AMENDMENT OF SOLICITATION/MODIFICATION OF CONTRACT				1. CONTRACT ID CODE		PAGE OF PAGES 1	
2. AMENDMENT/MODIFICATION NO. 0001		3. EFFECTIVE DATE 8/18/03		4. REQUISITION/PURCHASE REQ. NO.		5. PROJECT NO. (If applicable)	
6. ISSUED BY US Army Corps of Engineers, Philadelphia Wanamaker Building, 100 Penn Square East Philadelphia, Pennsylvania 19107-3390		CODE		7. ADMINISTERED BY (If other than Item 6) Michelle Bertoline, 215-656-6914		CODE	
8. NAME AND ADDRESS OF CONTRACTOR (No., street, county, State and ZIP Code)				(✓) 9A. AMENDMENT OF SOLICITATION NO. DACW61-03-B-0013			
				X 9B. DATED (SEE ITEM 11) 7/24/03			
				10A. MODIFICATION OF CONTRACTS/ORDER NO.			
				10B. DATED (SEE ITEM 13)			
CODE		FACILITY CODE

DELAWARE BAY COASTLINE, DELAWARE & NEW JERSEY, ROOSEVELT INLET, LEWES BEACH, DELAWARE

14. DESCRIPTION OF AMENDMENT (continued)

PROJECT TITLE: Delaware Bay Coastline, Delaware & New Jersey, Roosevelt Inlet, Lewes Beach, Delaware

RIPRAP GRADATION CURVES

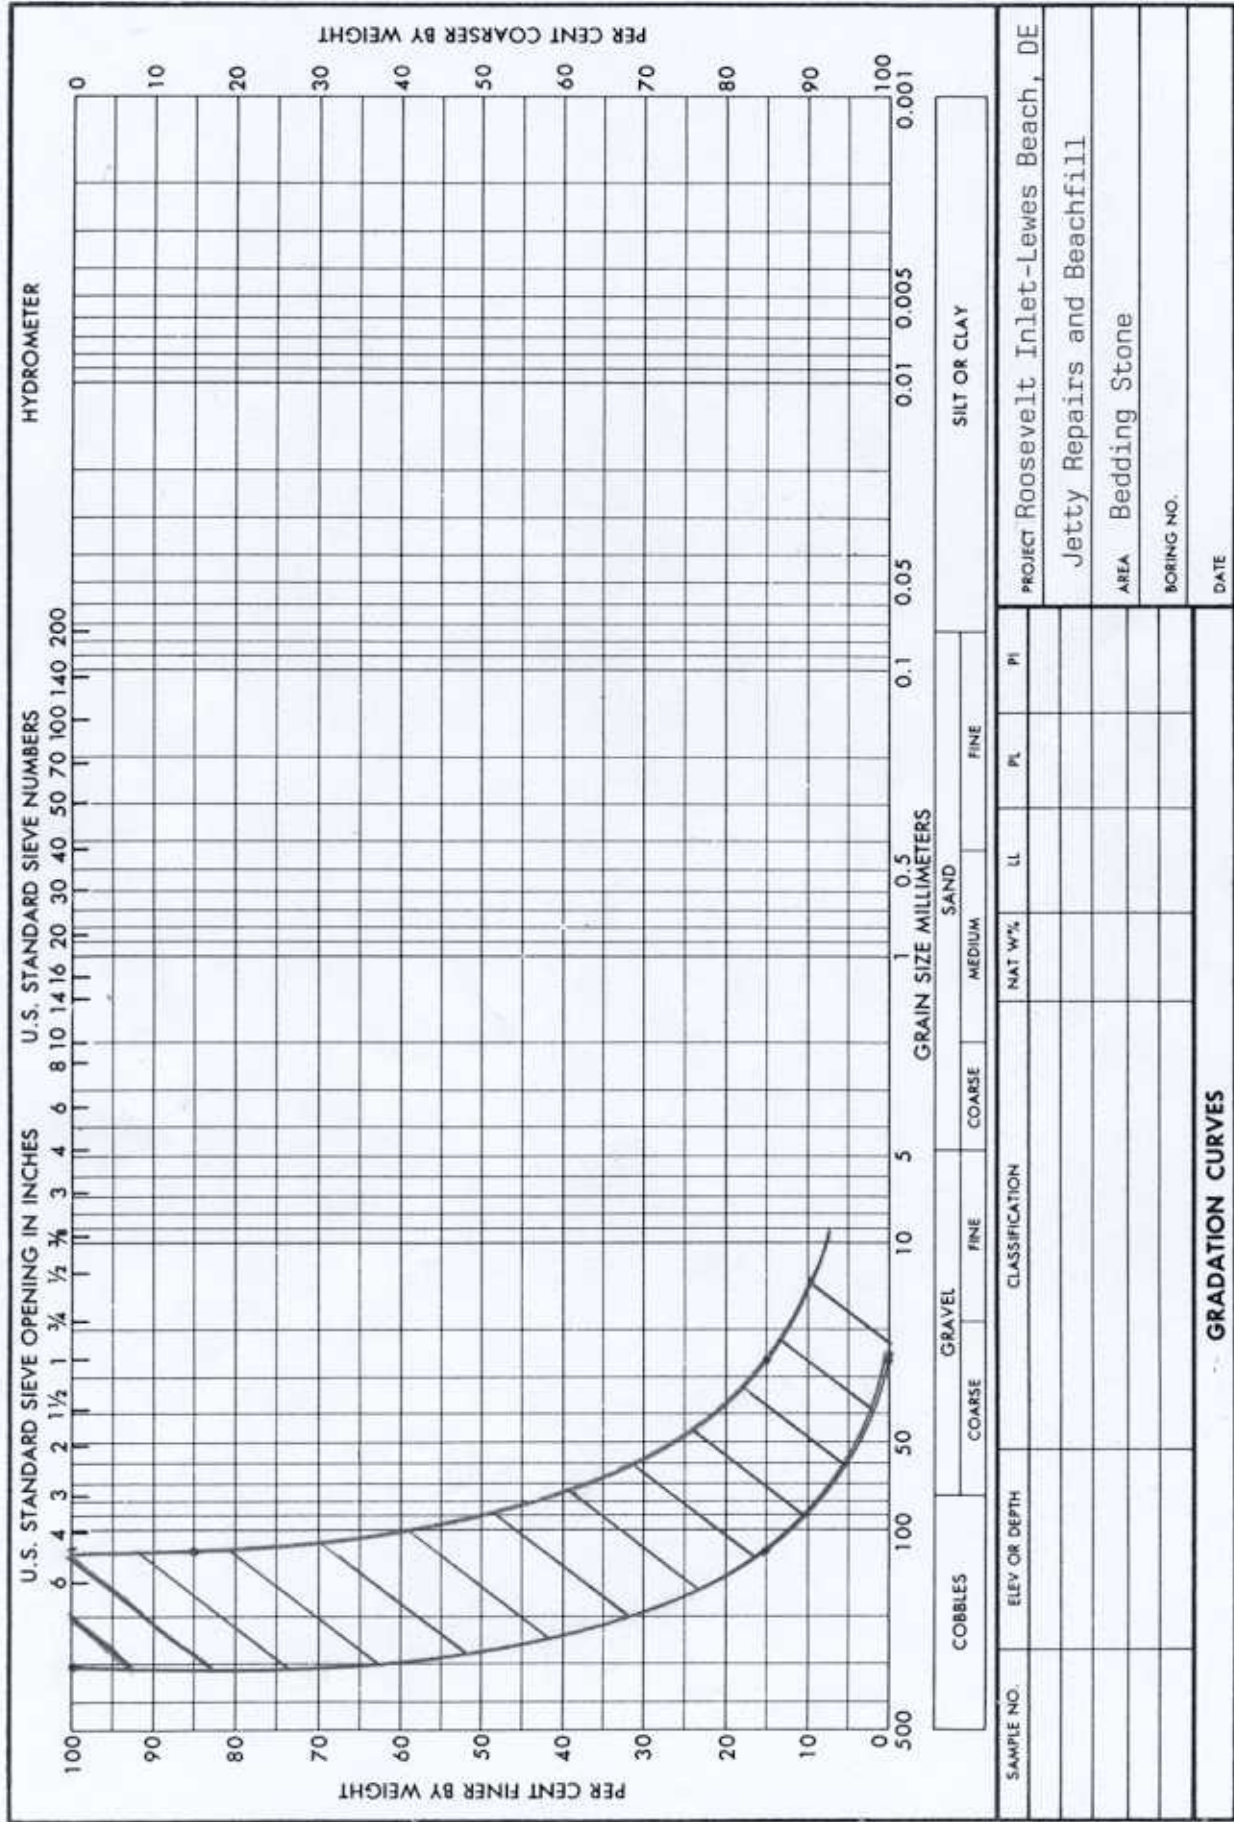
The gradation curve for the jetty stone is attached to this section.

Percent Lighter By Weight	Limit of Stone Weight in Pounds
100	7230 - 5000
50	2400 - 1600
15	500 - 225
